Service Note						
Product	Description:	Service note no.				
Wizard	Hardware Corrections for wizards	720 10 T028

Corrections Wizard products:

Top cover with stuck on alu foil, with the nescessary cut outs

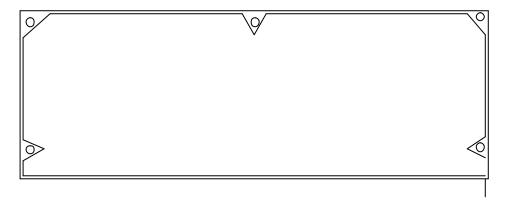
- #1 Check if IC 8 is ISSI brand. If it is replace IC8 and battery.
- **#2** Problems with word clock. Change R296 from 3M3 to 10k.
- **#3** Lock problems on S/P-DIF input at 96k. modif. At IC48 (correction sheet 1701).
- #4 Check if IC35, IC36 and IC41 is the right type (33079).
- #5 If version 2 mic amp is mounted always replace with version 5. -If version 3 is mounted look if it is updated (If not replace with version 5).
- **#6** Pedal input update correction sheet 1657, 1658. Remember to remove old correction if updating.
- #7 Ic 6 on the PLL-print change to 74AHC00, and the C7 og C13 Change to 56pF.
- #8 Cut outs in the foil where the screws come through the top cover.
 That must be done before the foil is clued to the top cover according to the enclosed drawing.

Check for (including the cover) for loose alu chips.
